FINAL DRAINAGE REPORT

HANNAH RIDGE AT FEATHERGRASS FILINGS 5, 6 & 7

October 2018

SF-18-038
SF-18-039
SF-18-040

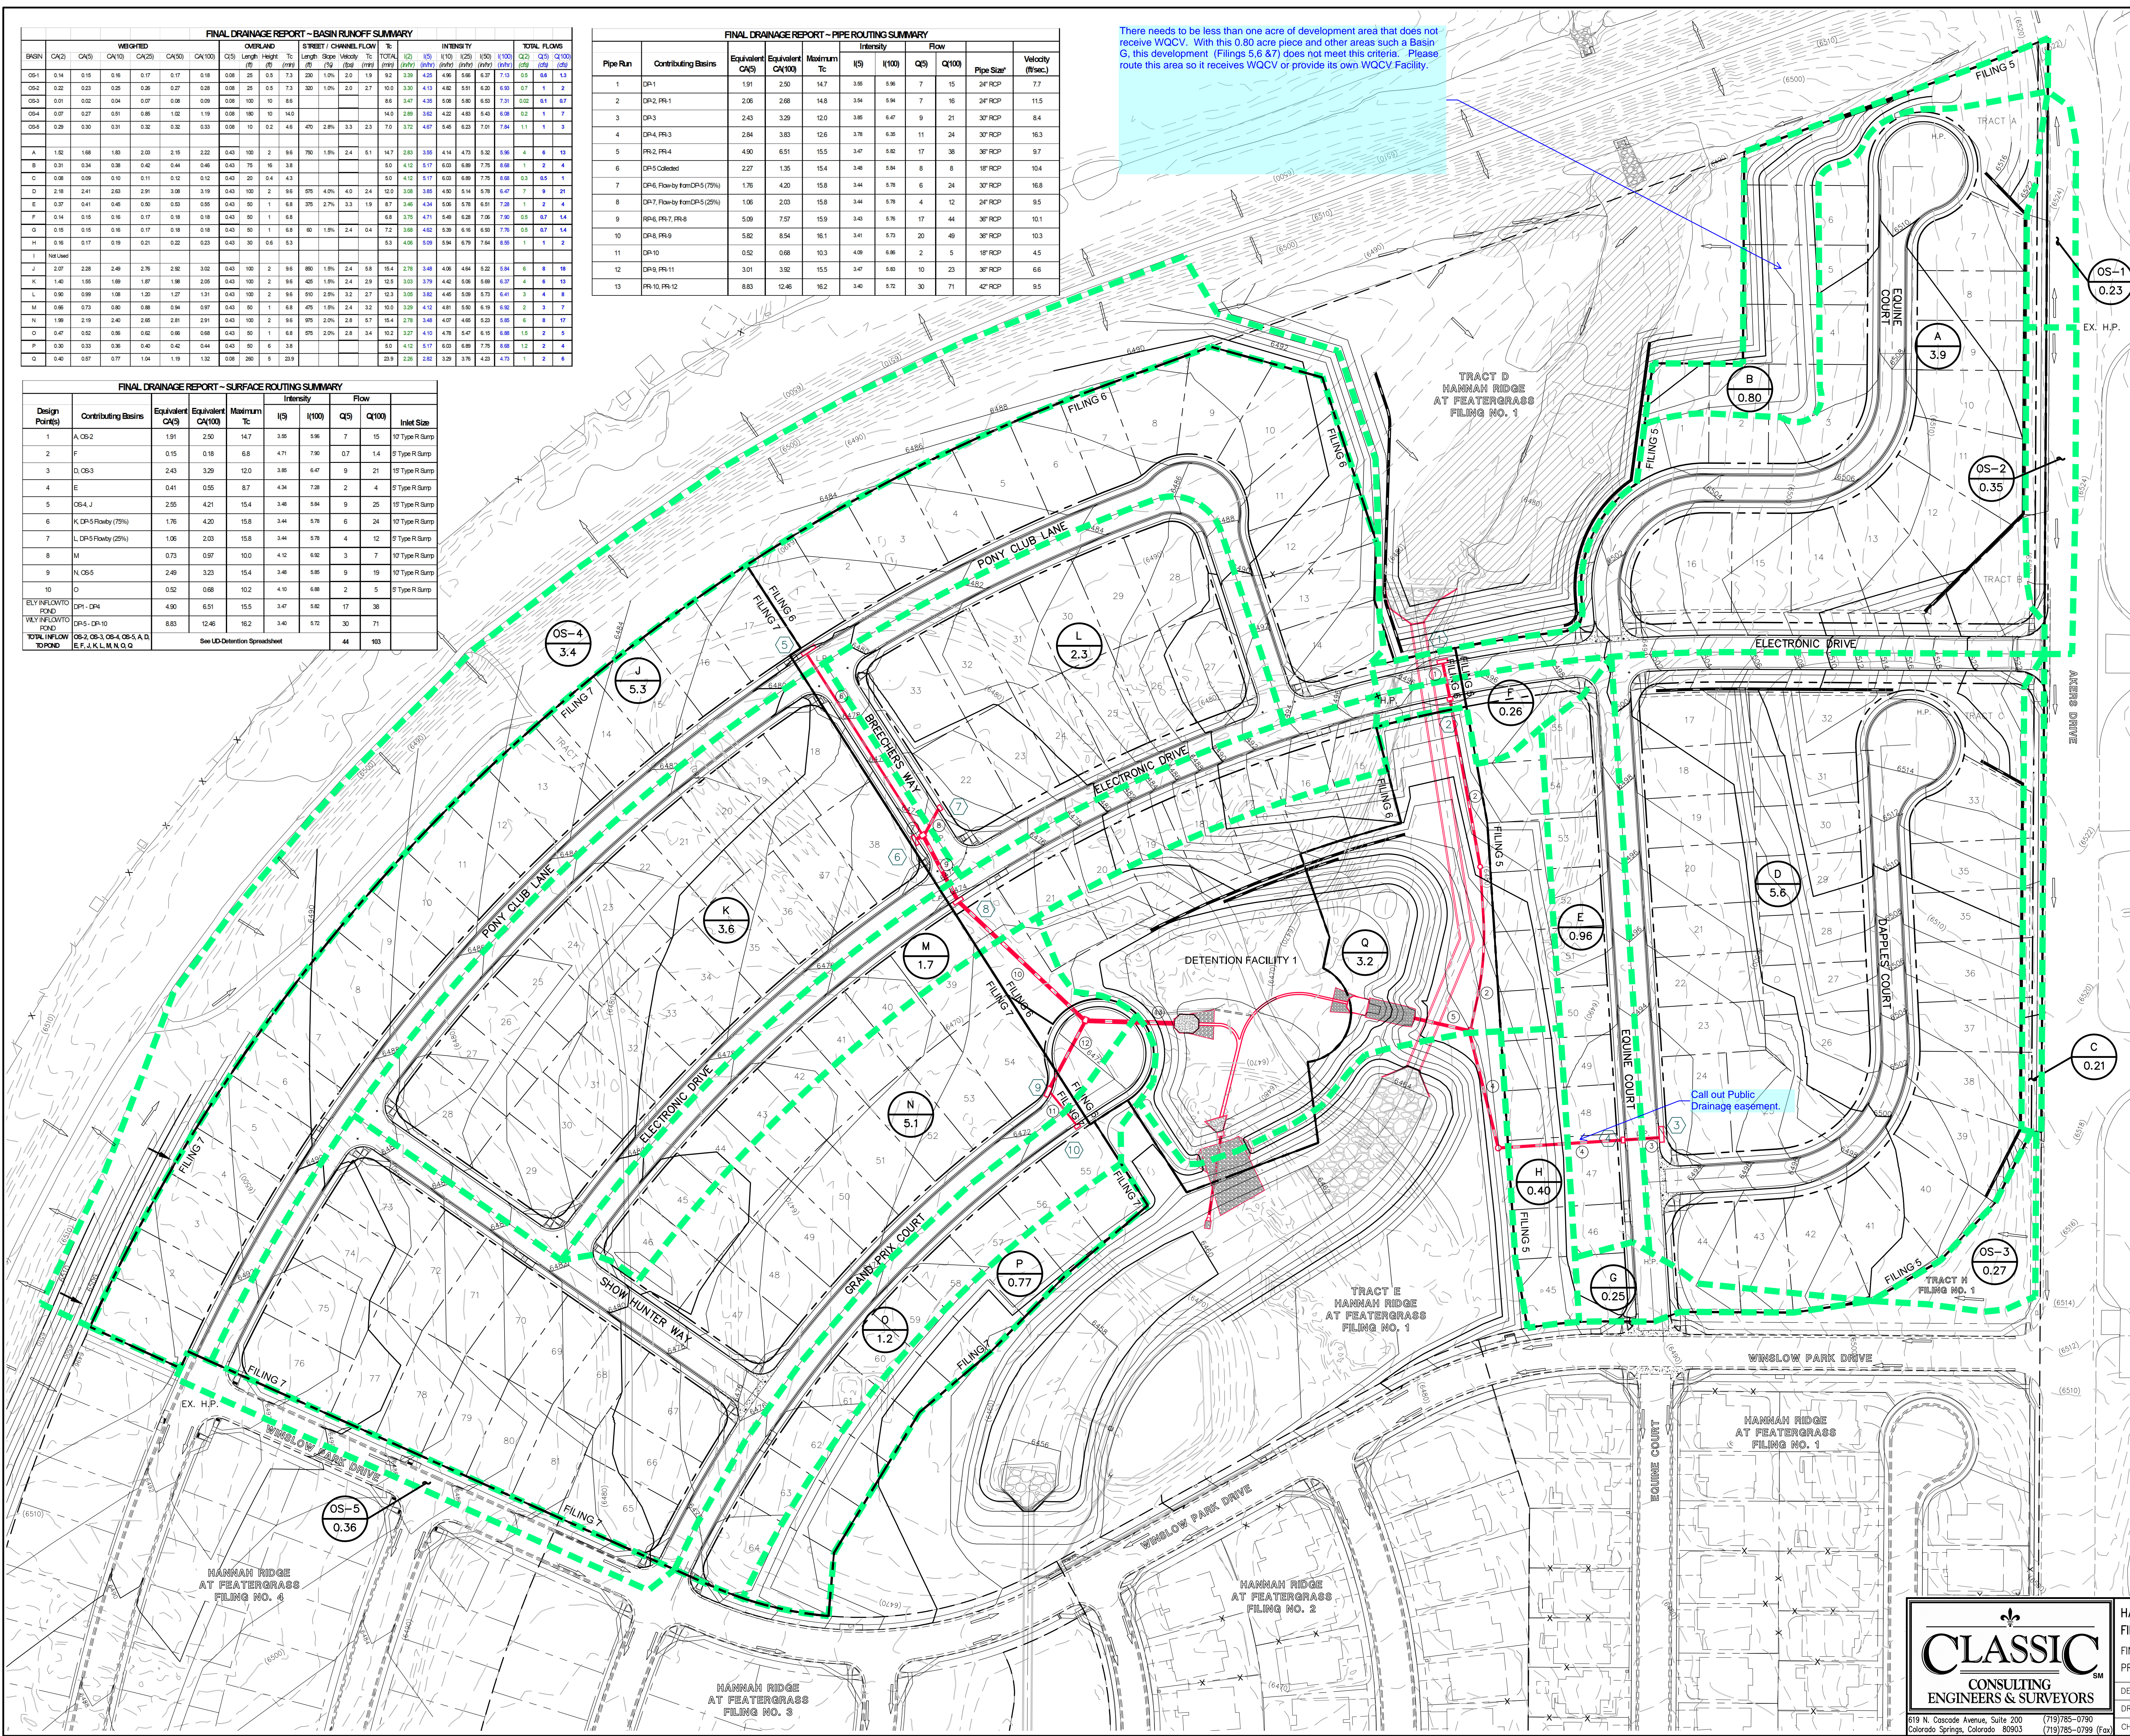
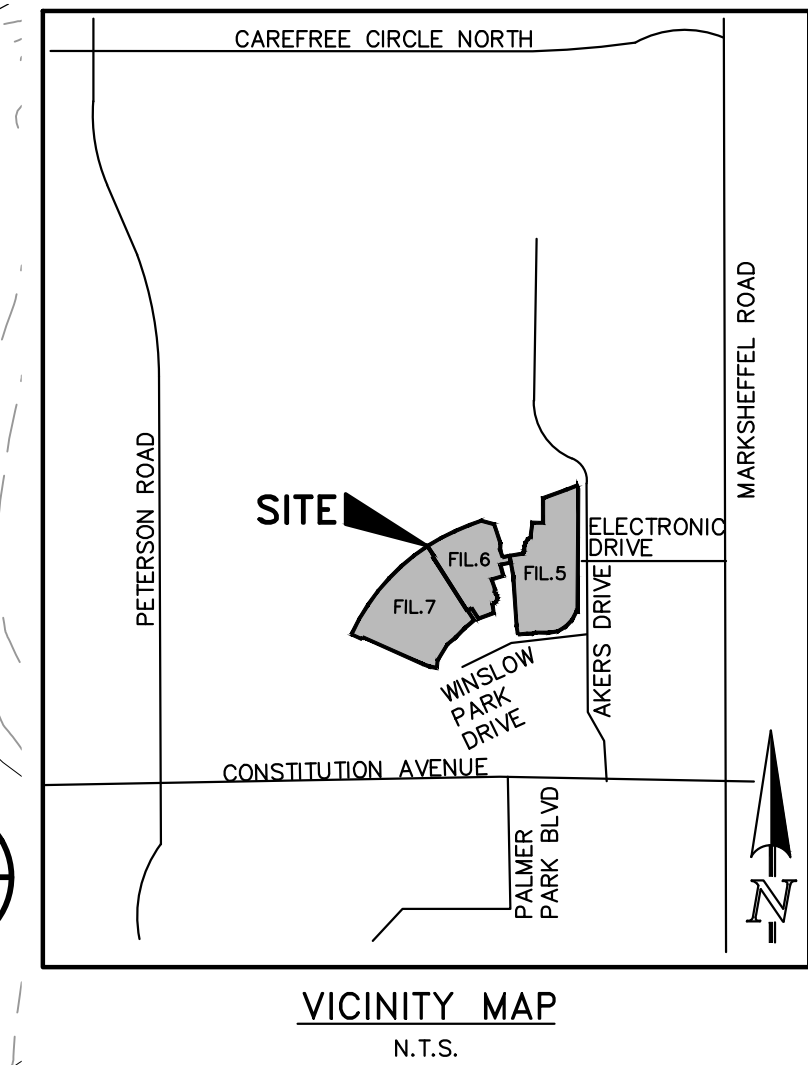
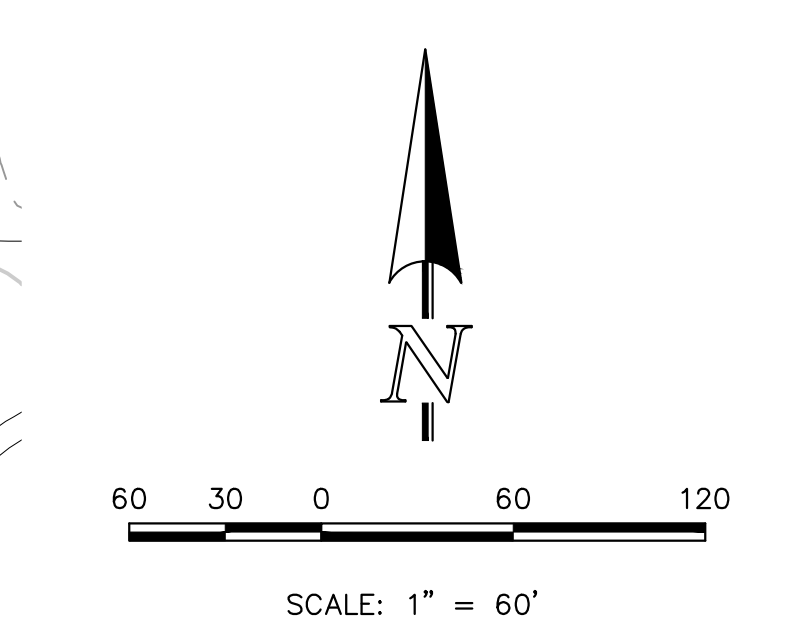
There needs to be less than one acre of development area that does not receive WCV. With this 0.80 acre piece and other areas such as Basin G, this development (Filings 5 & 6 & 7) does not meet this criteria. Please route this area so it receives WCV or provide its own WCV Facility.

There needs to be less than one acre of development area that does not receive WQCV. With this 0.80 acre piece and other areas such a Basin G, this development (Filings 5,6 &7) does not meet this criteria. Please route this area so it receives WQCV or provide its own WQCV Facility.

There needs to be less than one acre of development area that does not receive WQCV. With this 0.80 acre piece and other areas such a Basin G, this development (Filings 5,6 &7) does not meet this criteria. Please route this area so it receives WQCV or provide its own WQCV Facility. Or adjust the overall plan accordingly.
